Ref:	NR/L2/ELP/27009/MOD C11
Issue:	1
Date:	03/12/2011
Compliance date:	03/03/2012
Page	1 of 2

OVERHEAD LINE CAMPAIGN CHANGES – DATA SHEET

REPLACEMENT OF PLASTIC DROPPER SLEEVES PRONE TO ULTRA VIOLET DEGRADATION

COMPONENT Black nylon / plastic dropper sleeves, OLEMI type 146/20/2

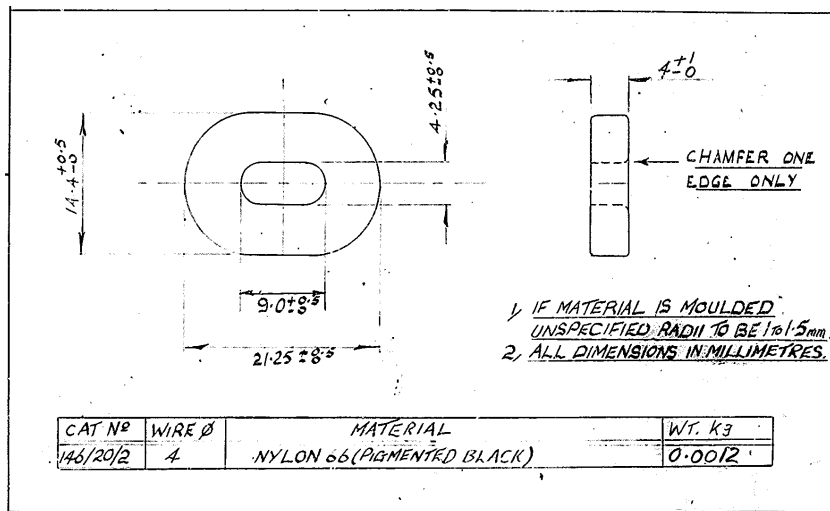
PROBLEM Dropper sleeves crack and detach from dropper, leading to a risk of the dropper fouling pantograph envelope.

Fit stainless steel type 91/10117 (OLEMI number 145/814/001) or keyring type 91/2435. The keyring type can be fitted to existing droppers.
